Nick Culhane
Highway Consultant

Planning Application F/22/93835

MOORLANDS FARM, BOTLEY ROAD, WEST END, SOUTHAMPTON, SO30 3HD

This Highway Technical Note Addendum has been produced in response to comments made by Hampshire County Council (HCC) and National Highways (NH) on the above planning application in their formal consultation dated 13th October and 25th October 2022 respectively.

Visibility Cross Section

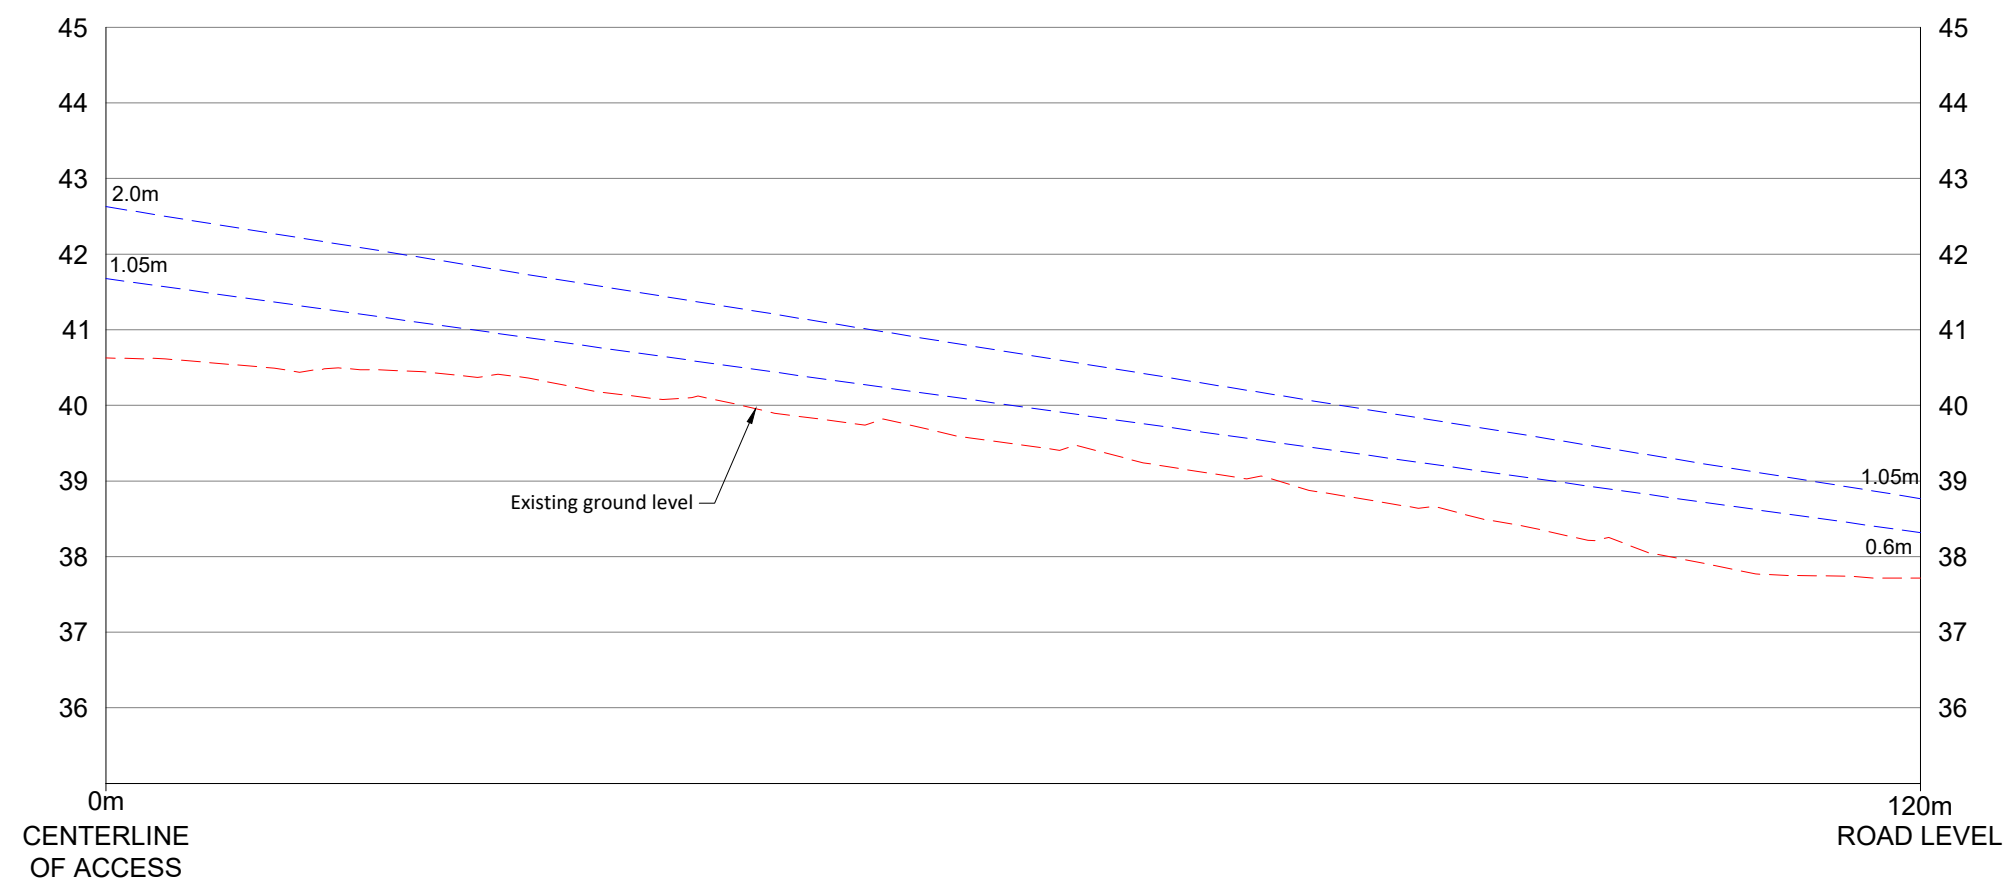
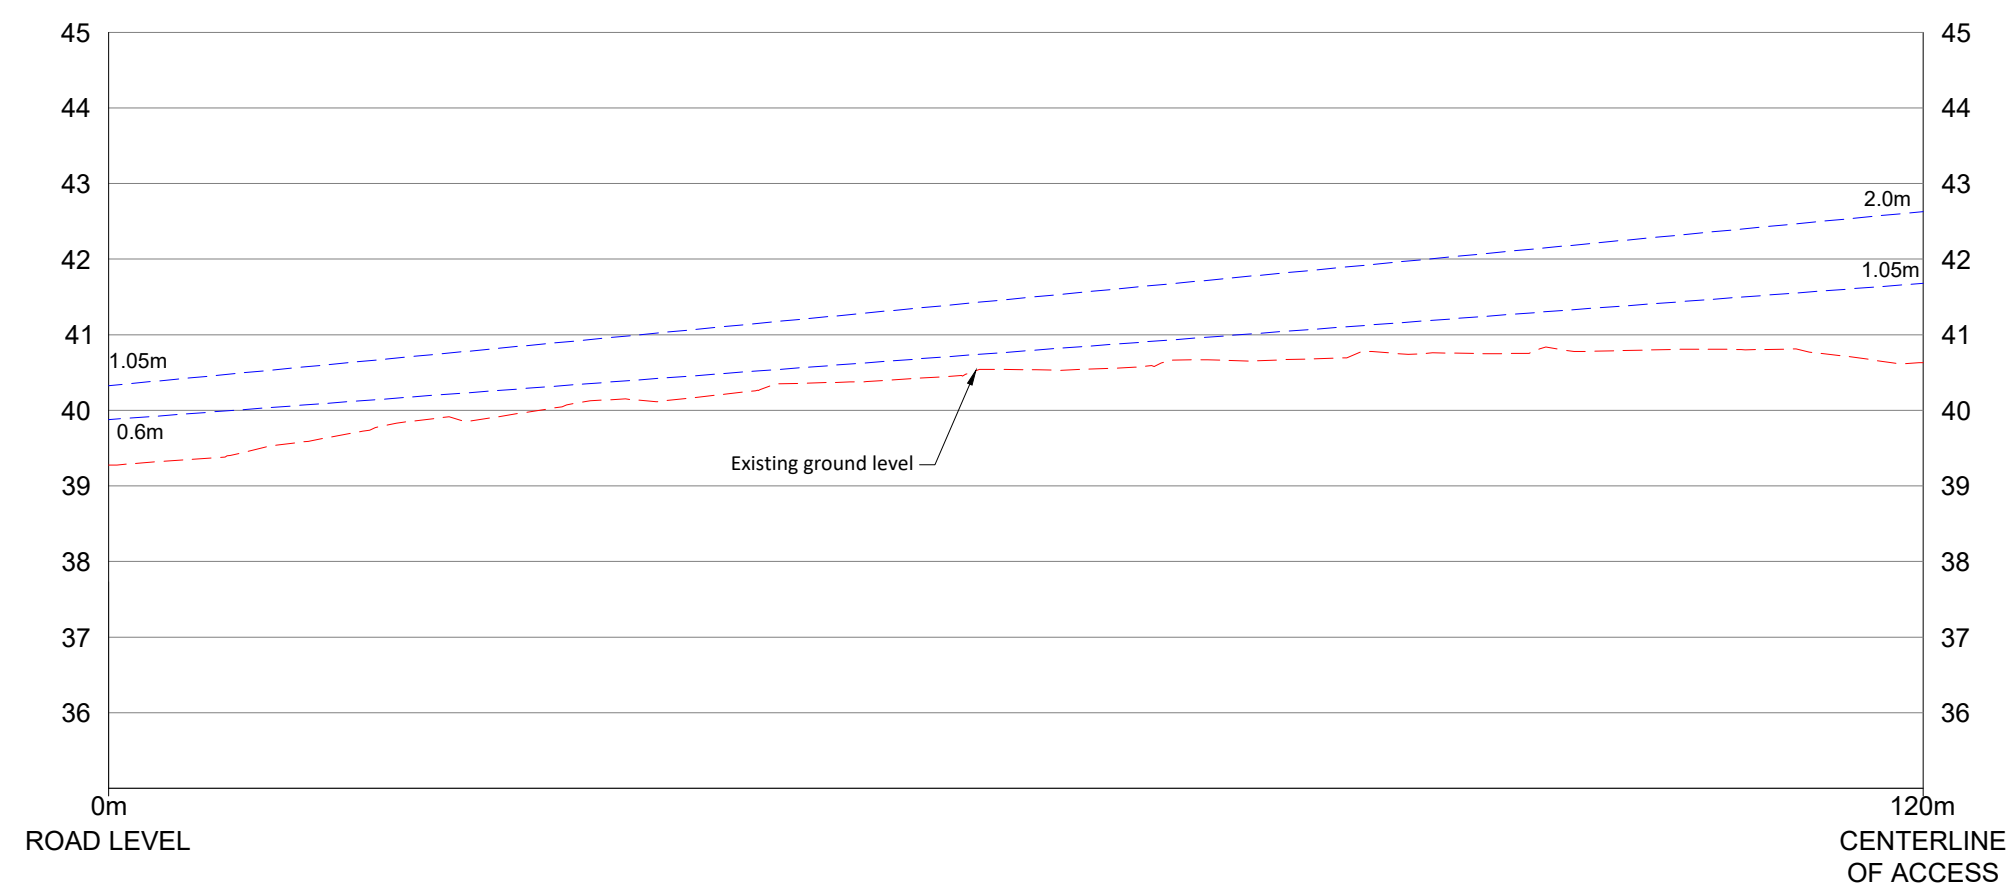
Taking the visibility issue first, whilst accepting the available visibility for the previous application which generated greater traffic movements, HCC have now questioned whether the splays can be physically achieved due to a fall in levels to the west and the brow of the hill, in this direction.

Drawing numbered NJC-007 is included as [Appendix 1](#) to this Note which shows a cross section through Botley Road at the point of the existing access. The drawing shows the ability of a driver to see from an eye height of between 1.05m and 2.0m to an object height of between 600mm and 1.05m. It is evident that the levels and the brow of the hill do not affect the ability for appropriate visibility to be achieved.

Junction Improvements

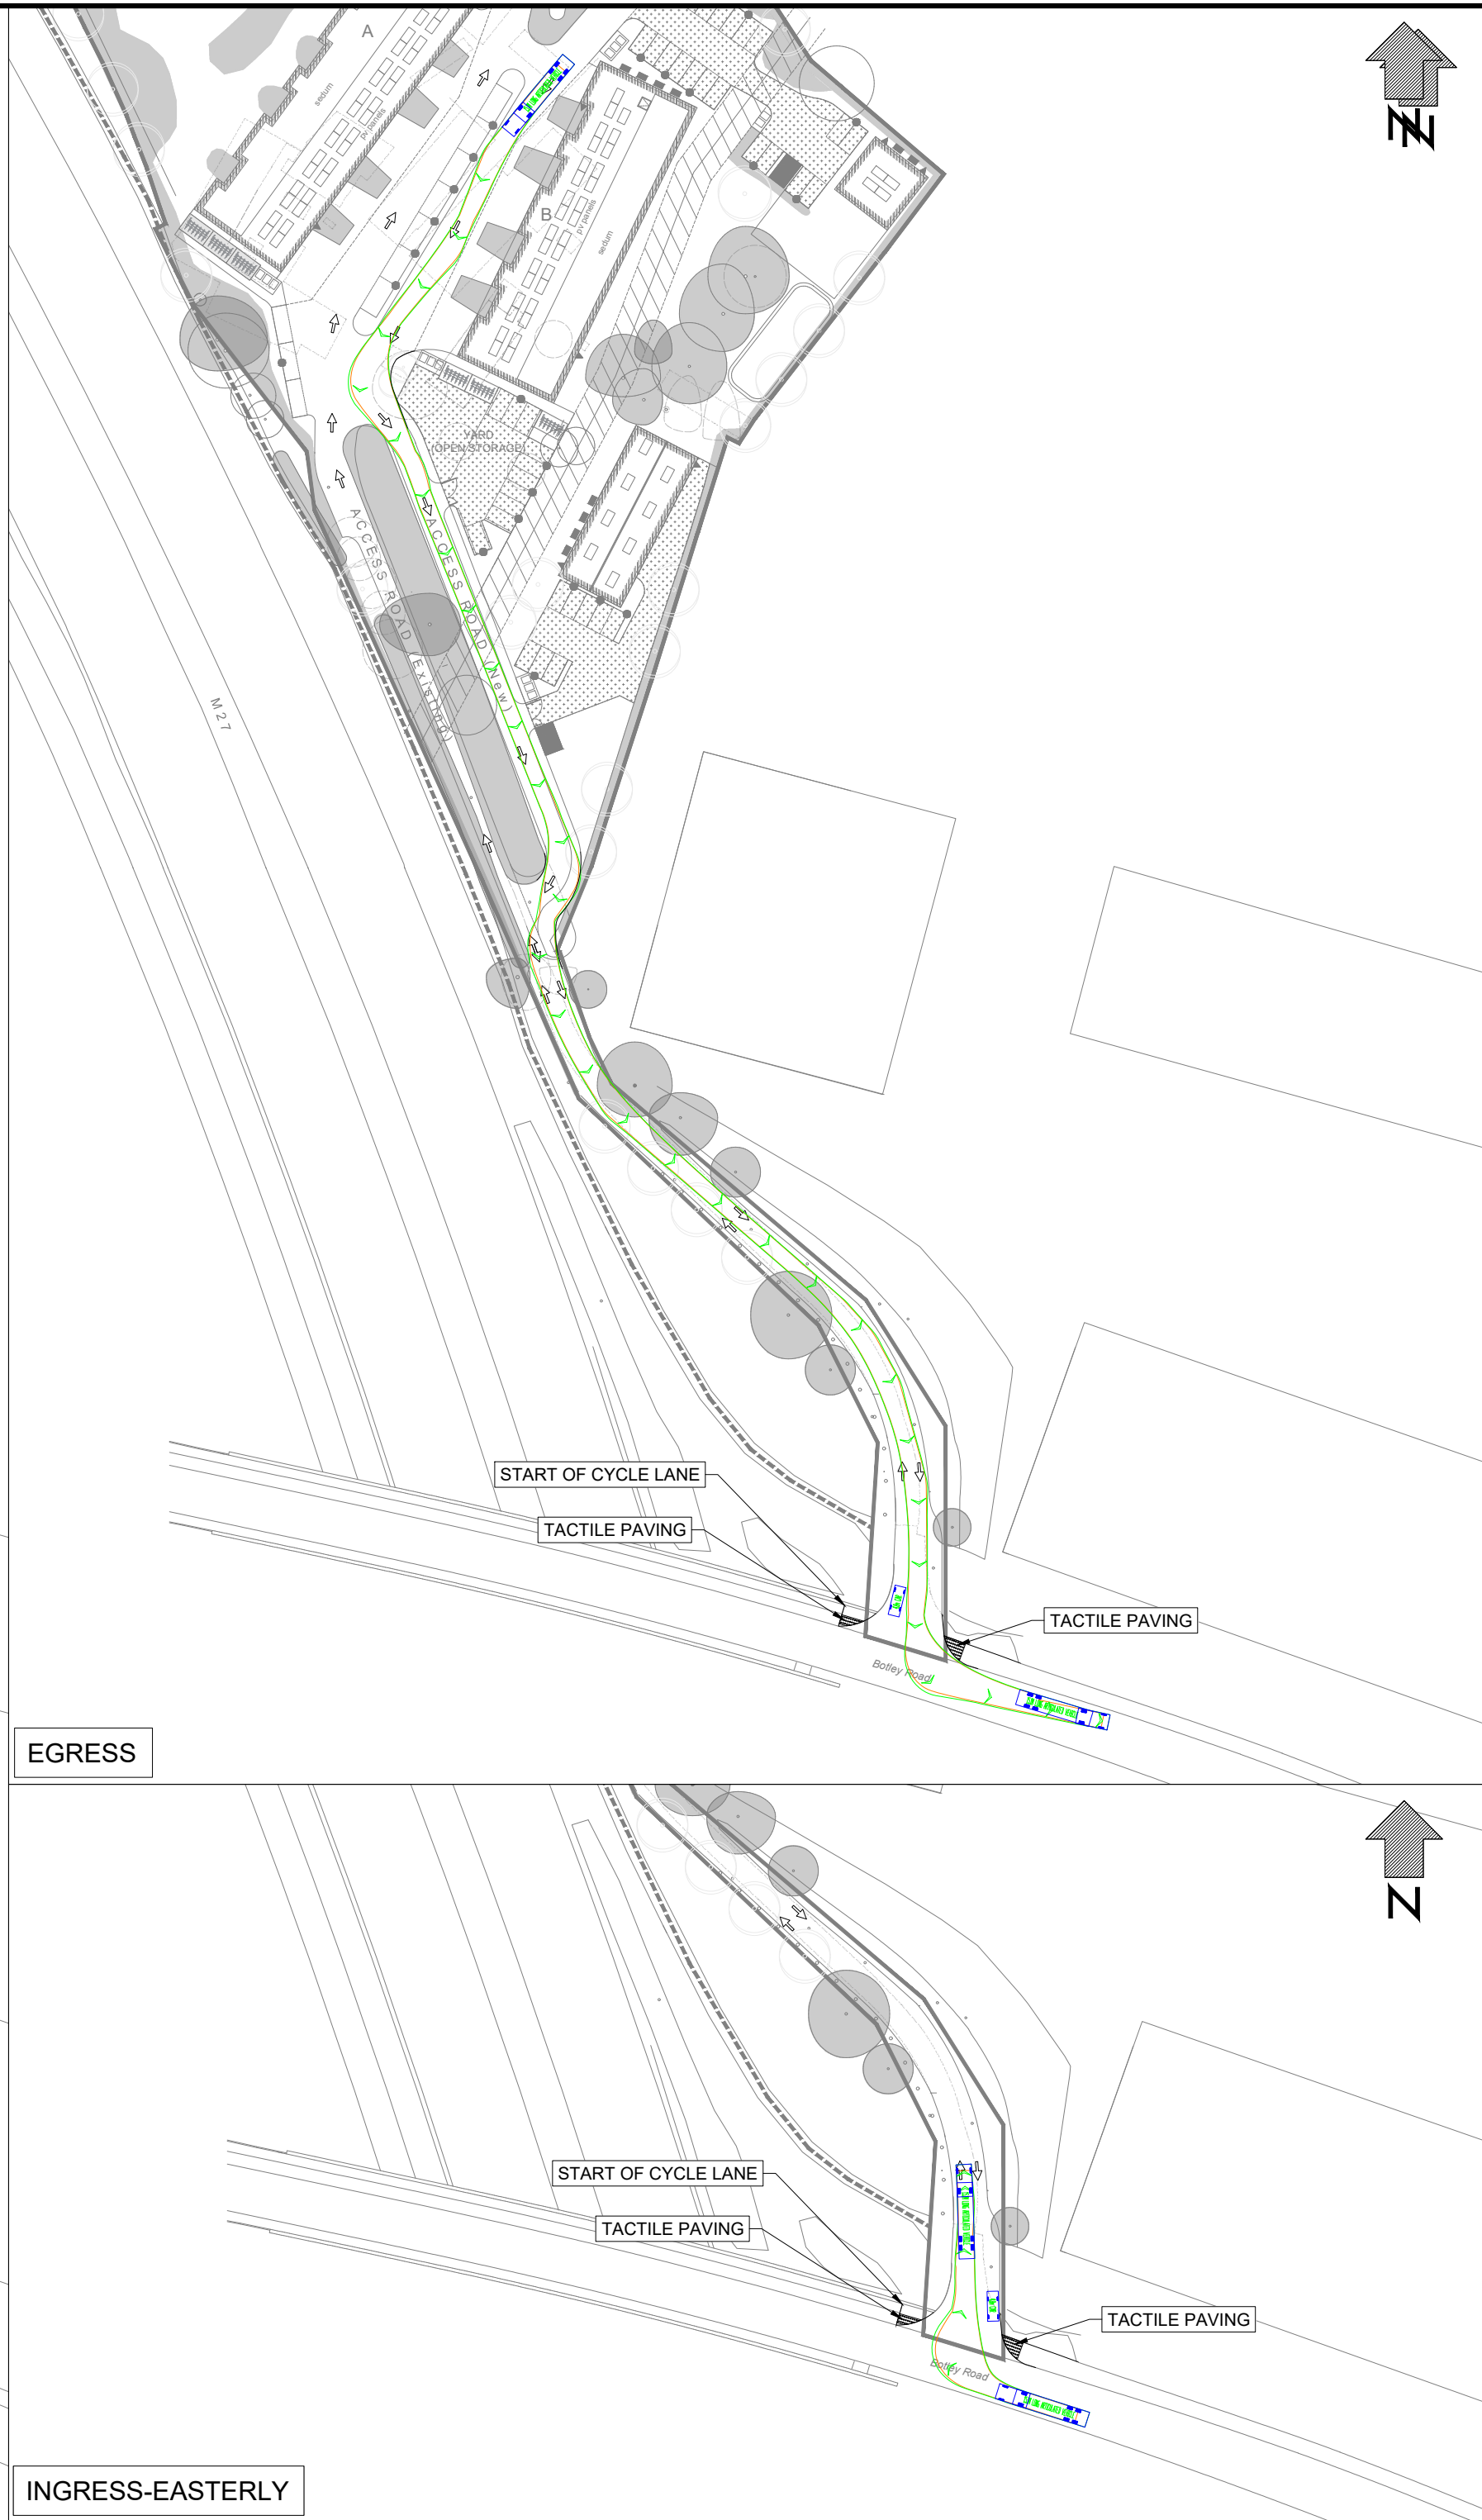
Concern was raised as to the increased use of the existing footway crossing, and potential conflicts with pedestrian and cyclists. Drawing numbered NJC-008 is therefore included as [Appendix 2](#) to this Note which shows the access now redesigned as a formal bell-mouth junction with tactile paving, to aid pedestrians at this point. The drawing demonstrates the principle of the proposal, although a more detailed design including construction details can be formulated as part of a formal Section 278 submission.

The access junction with the Botley Road has been designed to allow for a vehicle and an articulated lorry to pass one another at this point and this is demonstrated on drawing numbered NJC-010. Vehicles will not have to reverse out onto the Botley Road, therefore there will be no endangerment to pedestrians or cyclists using this section of Botley Road. The introduction of the Bellmouth junction with tactile paved dropped crossings will also enhance pedestrian safety at this point.
